STATE OF VERMONT
AGENCY OF TRANSPORTATION

PROPOSED IMPROVEMENT
BRIDGE PROJECT

MARLBORO
BRF 010-1 (43)

RECORD PLANS	
CONTRACTOR:	RENAUD BROTHERS, INC. - VERNON, VT
RESIDENT ENGINEER:	RON LEMAIRE
CONSTRUCTION BEGAN:	APRIL 8, 2014
CONSTRUCTION COMPLETE:	NOVEMBER 6, 2014
RECORD PLANS BY:	RON LEMAIRE & JENNA HYDE
I HEREBY CERTIFY THAT ALL THE CONSTRUCTION REQUIRED BY THIS SET OF DRAWINGS HAS BEEN ACCOMPLISHED AS INDICATED HEREIN.	
BY	RESIDENT ENGINEER
DATE 02/11/2016	
NOTE: Any further information concerning final quantities, amounts or other details relative to this project may be found at Central Files in the electronic archives.

393+50 • REVISED BRIDGE HAS 6 GIRDERS

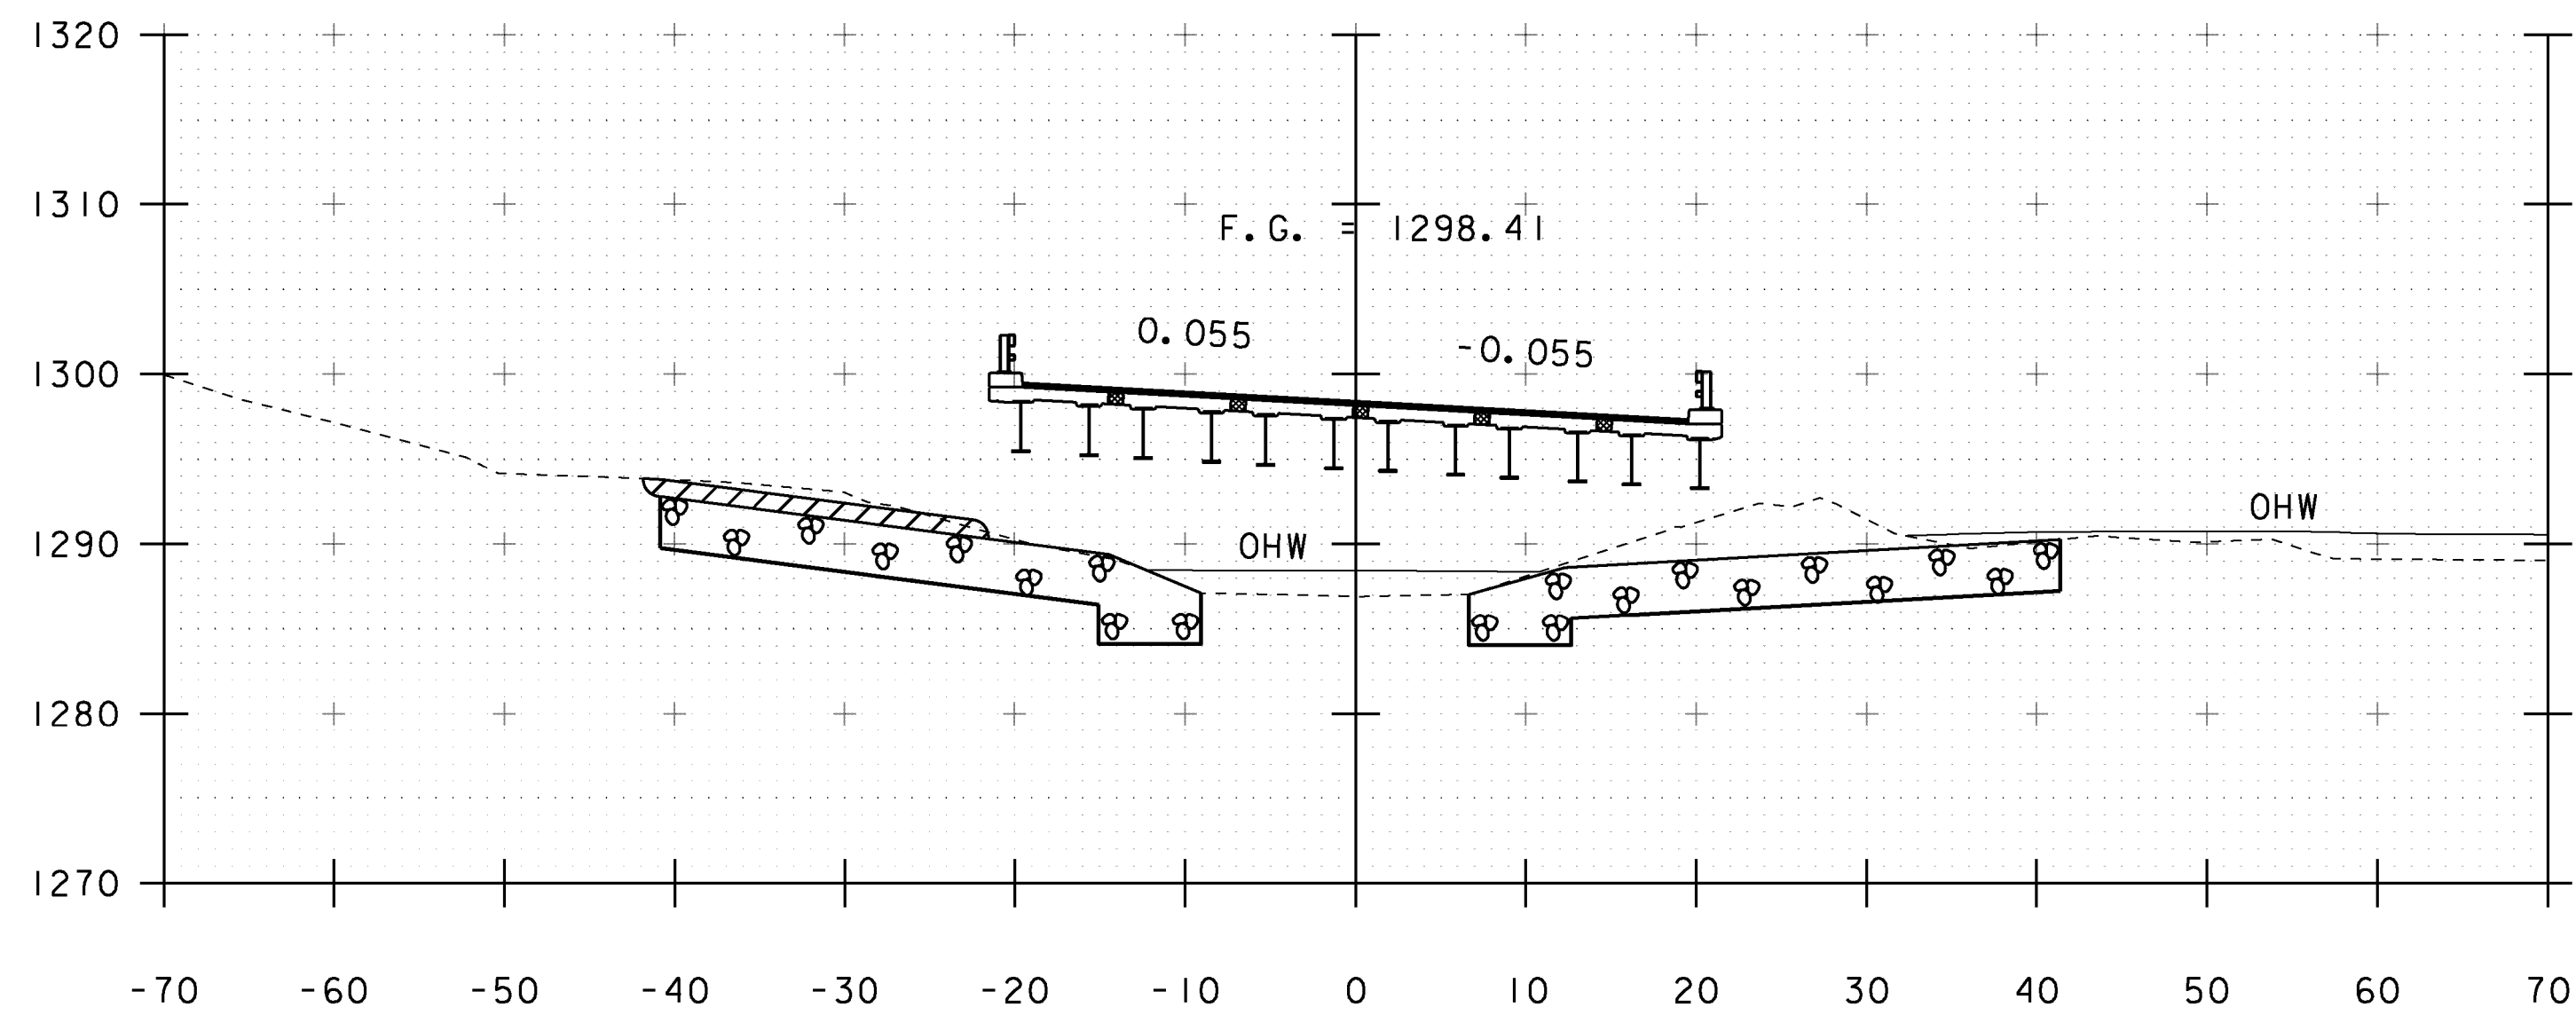
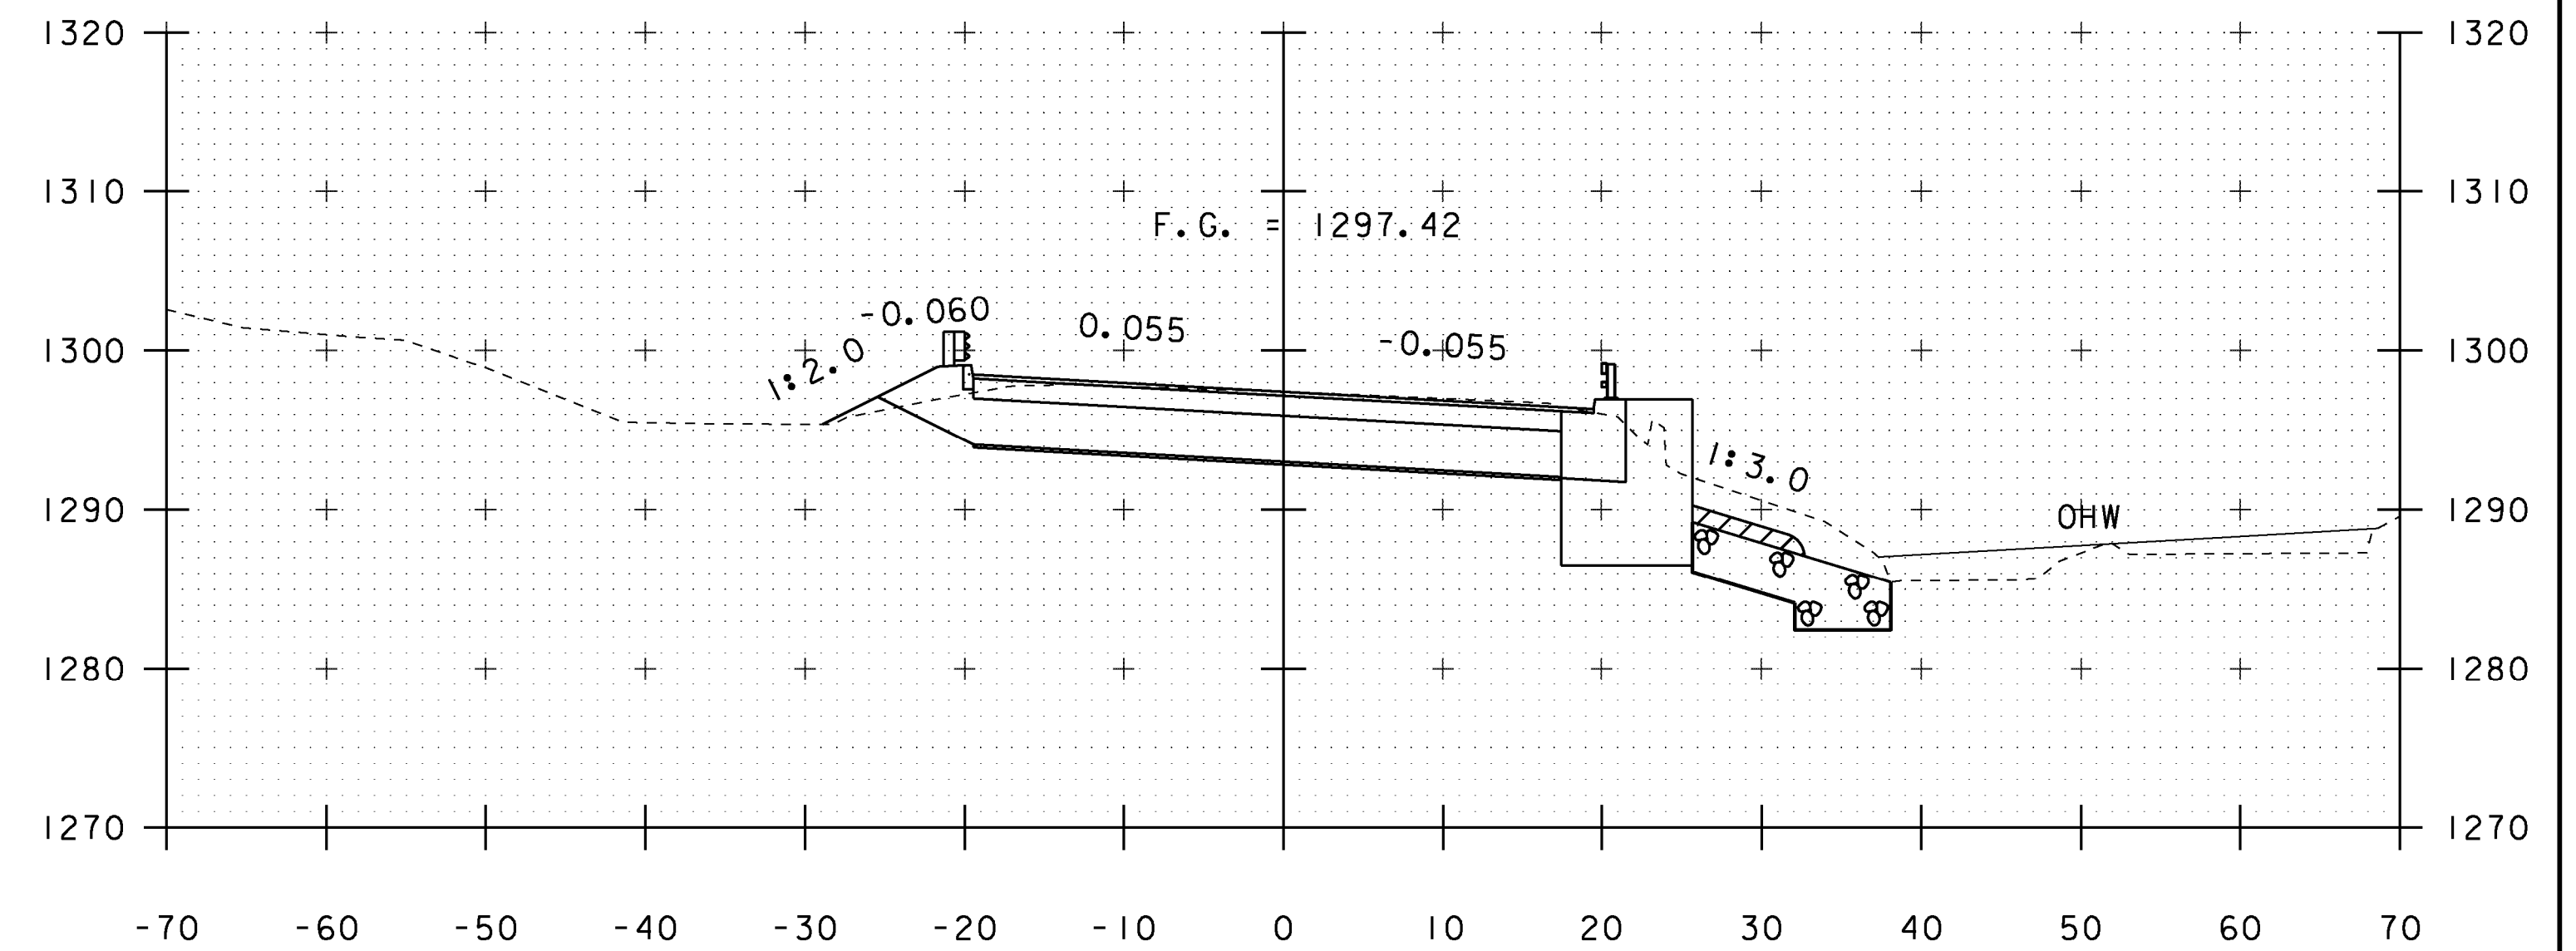
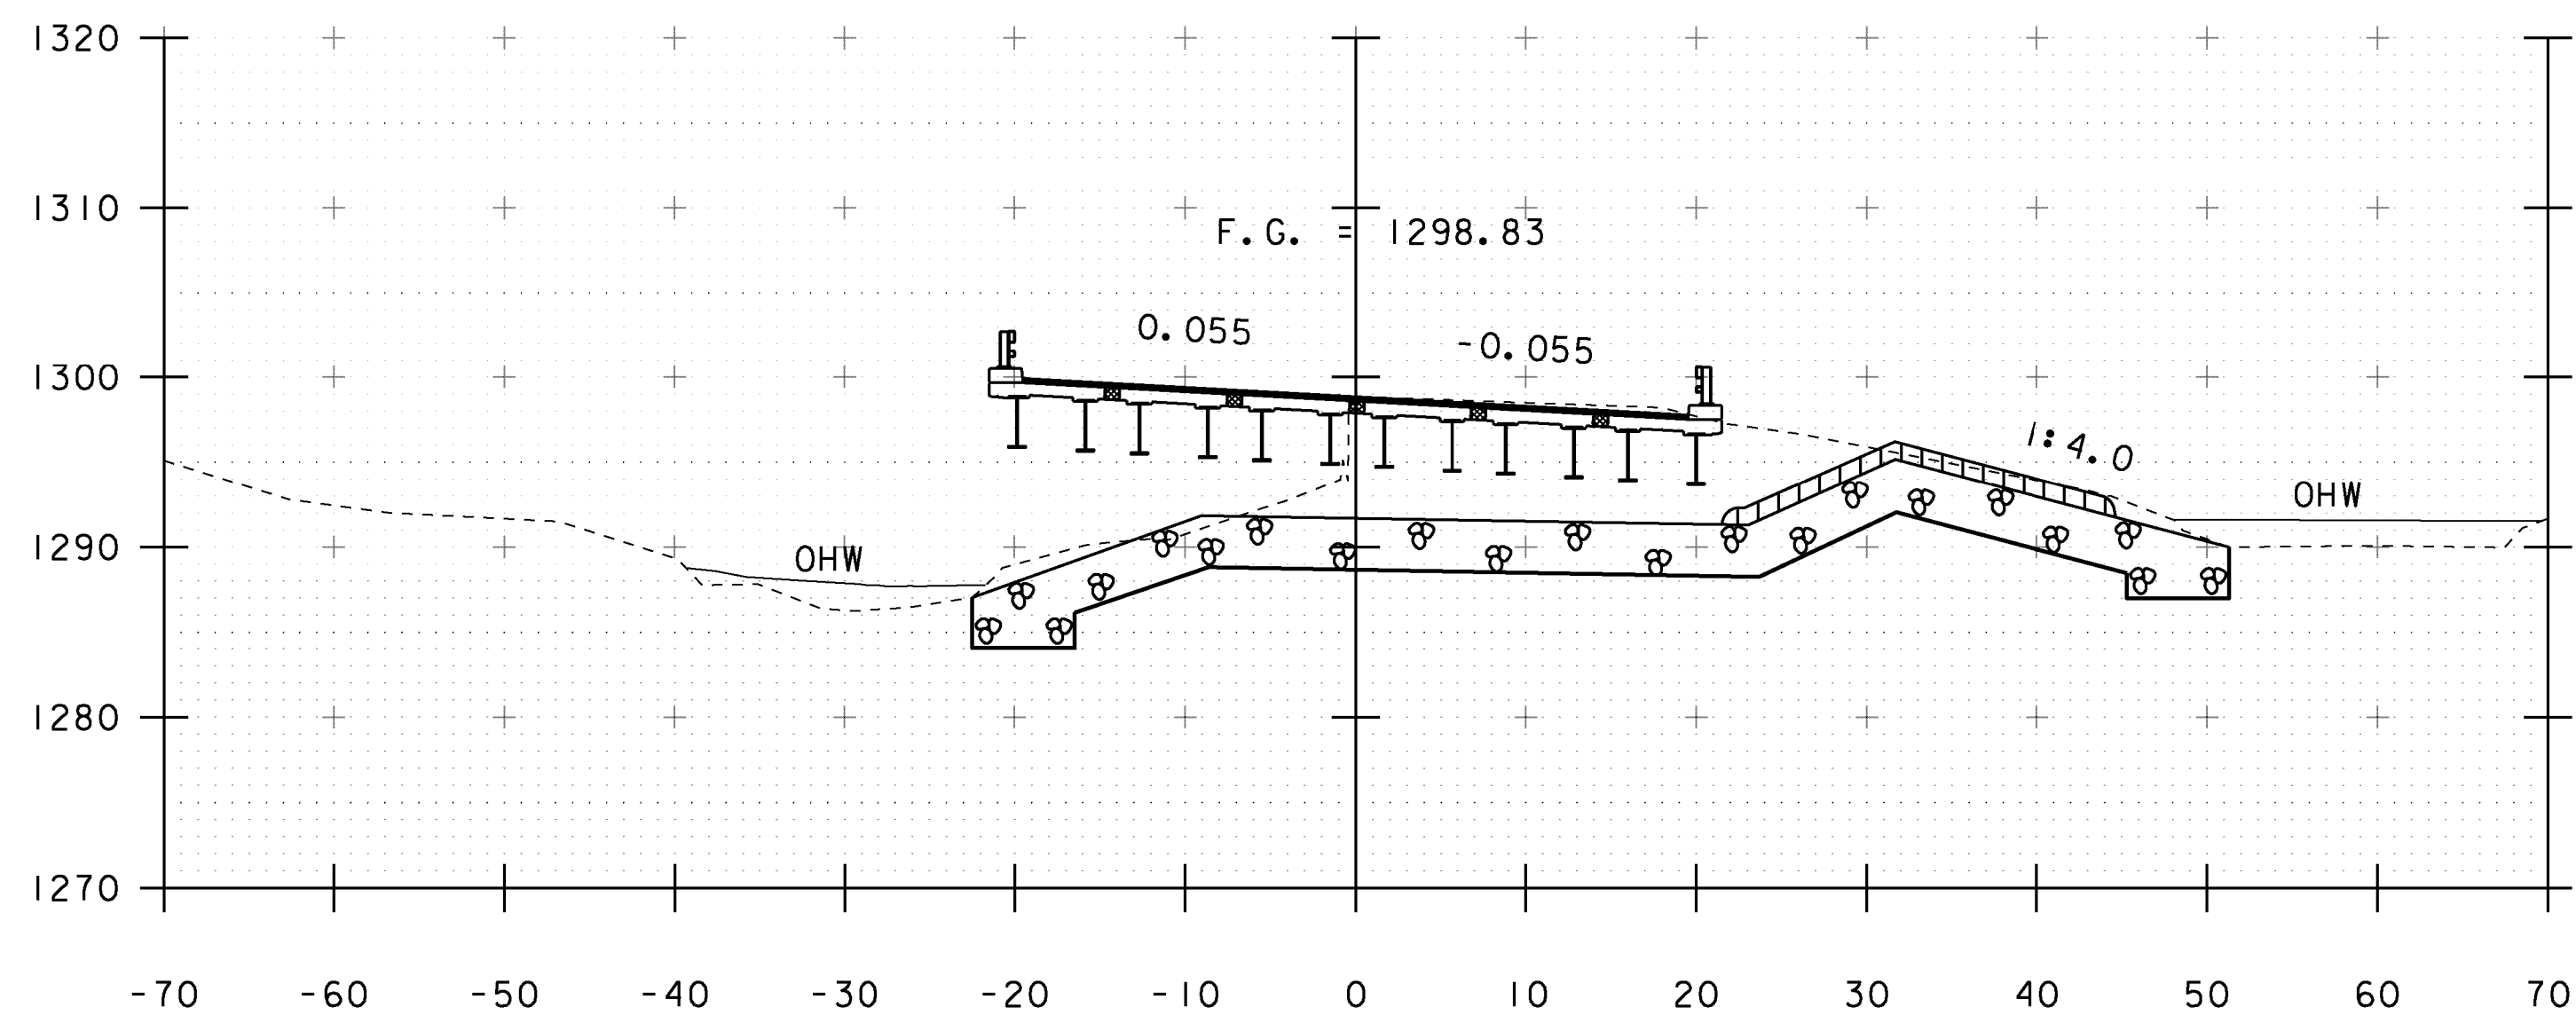
394+00
END BRIDGE STA ~~393+93.78~~
393+93.87

393+25
BEGIN BRIDGE STA ~~393+12.23~~
393+12.14
